Response to the comments

Mingyi Dong

Comments from Paul

主题: RE: Response to the comments and suggestions for TPC (Chaper 6)

Old definition

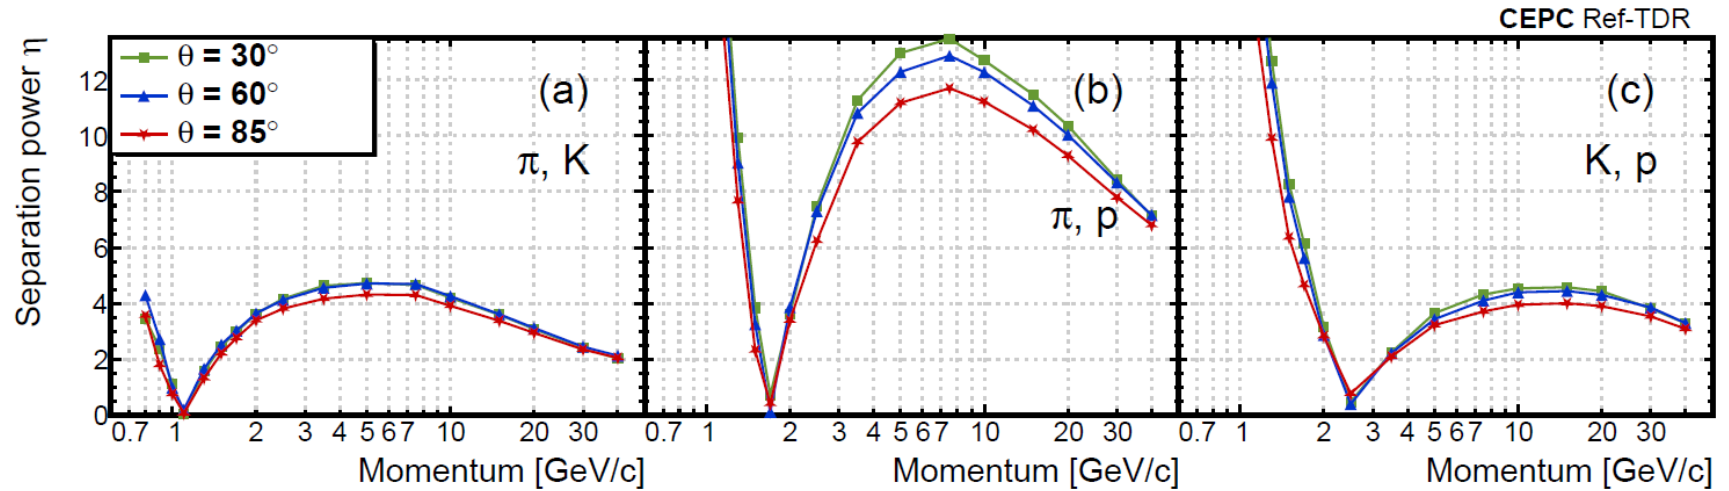
However for the preliminary TDR I notice that the questionable definition of the separation power is still there (Eq.5.5 p.170 and Eq.6.8 p. 209, and Fig.6.36 which makes use of this formula).

- We have revised the equation defining particle identification capability according to the definition used in ILD TPC

New definition

The results with
the bug
(Figure 6.36 (old))

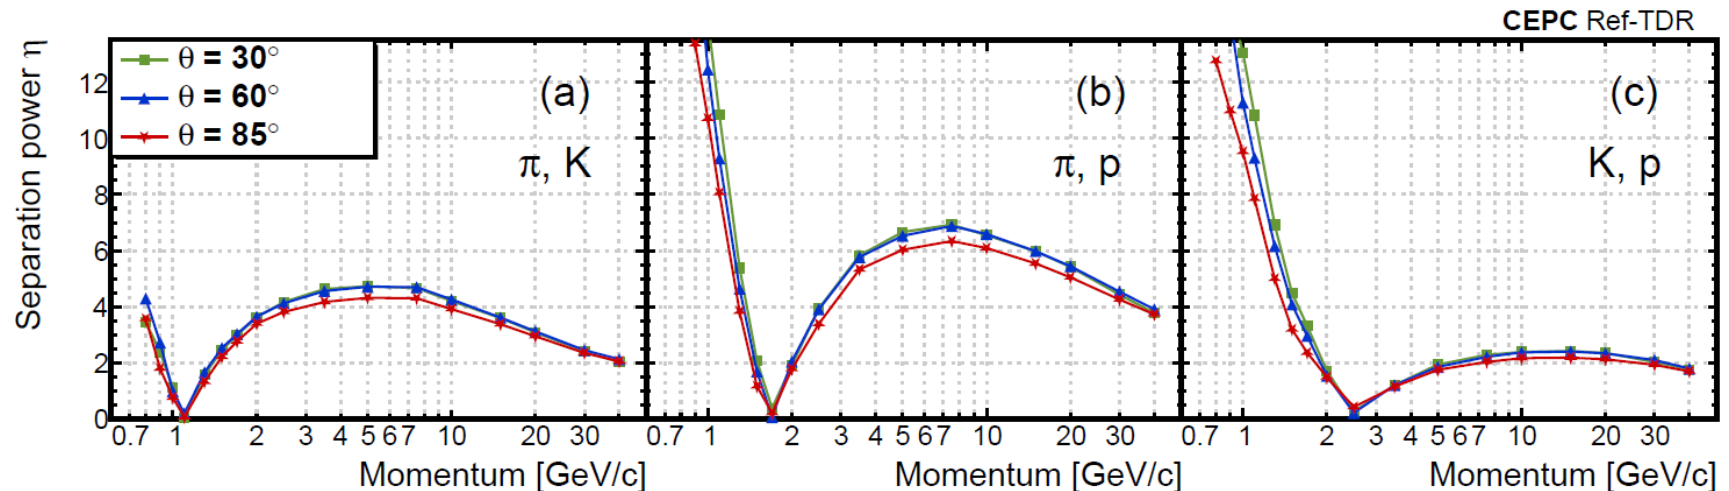
- While carefully checking the software, we found a bug in the plotting script. Specifically, An incorrect variable was used in the proton resolution (σ_p) calculation, resulting in a significantly lower value of σ_p . This led to incorrect K/p and π /p identification capabilities (better than the actual performance). We have fixed this bug and updated the plots for K/p and π /p separation power.

- While carefully checking the software, we found a bug in the original plotting script. Specifically, An incorrect variable was used in the proton resolution (σ_p) calculation, resulting in a significantly lower value of σ_p . This led to incorrect K/p and π/p identification capabilities (better than the actual performance). We have fixed this bug and updated the plots for K/p and π/p separation power (page 2 and 3 in attached PPT). We sincerely apologize for any confusion this error may have caused.

The results after
the bug was fixed

Updated Figure 6.36
using new definition

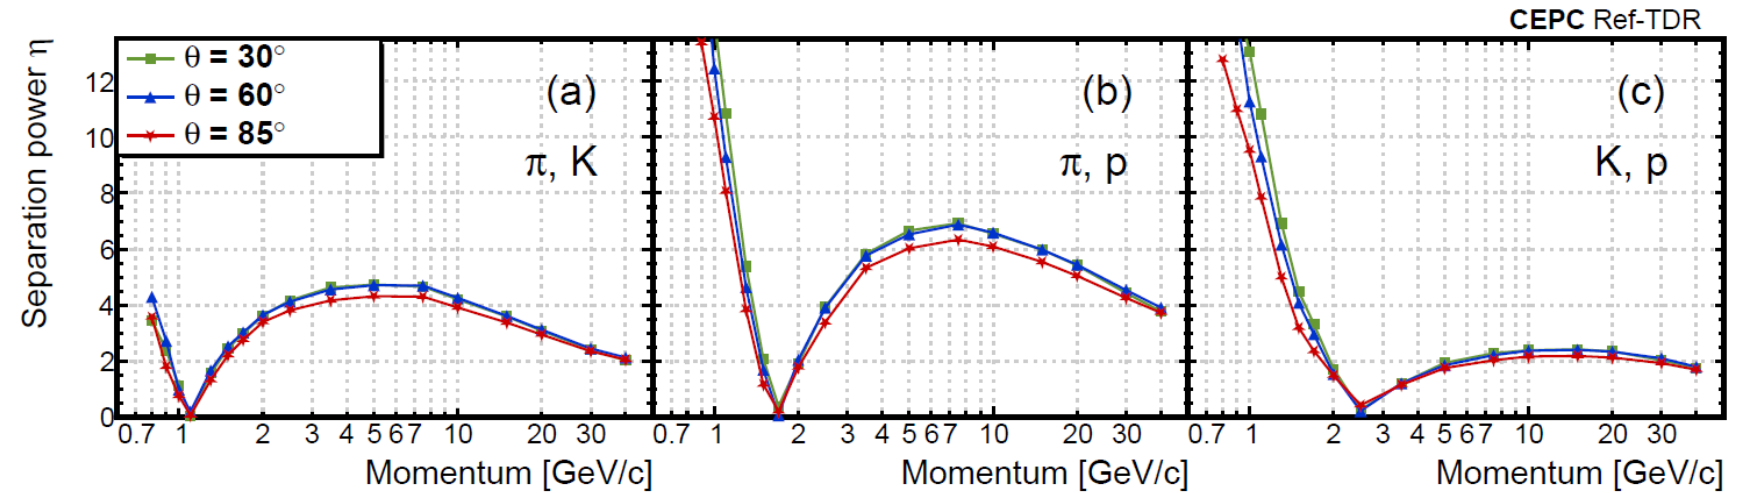
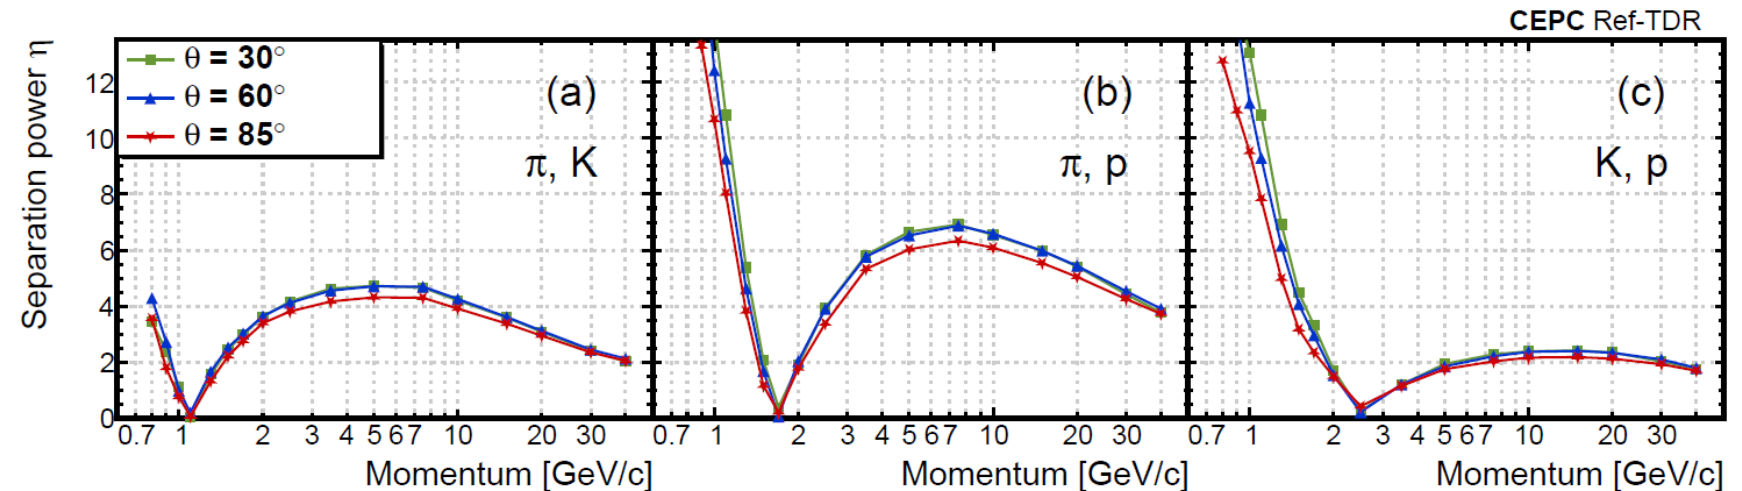
1. I acknowledge that you decided to go to the ALEPH definition of the separation power. Even if not numerically very different, I feel more comfortable like this (please note that the (wrong?) formula also appears in Chapter 5)
2. Yes, the membrane is immersed in the gas, so it has the same pressure both sides.
3. I think it is good that you decided to mention the non-uniformity of the electric field near the module edges, and the mitigation obtained by biasing the detector to a positive voltage. This requires however to encapsulate the pad plane in a high dielectric strength material. This is what we did in our test for LCTPC and in the T2K TPC.

1. We have revised the equation defining particle identification capability according to the definition used in ILD TPC (page 1 in attached PPT), and have updated the PID result plots (page 3 in attached PPT). Compared to the previous results, the difference in K/π separation power between the two definitions is less than 0.5%, as shown in page 4(attached PPT).

- We have updated the PID result plots using new definition of separation power

- Compared to the previous results, the difference in K/ π separation power between the two definitions is less than 0.5%
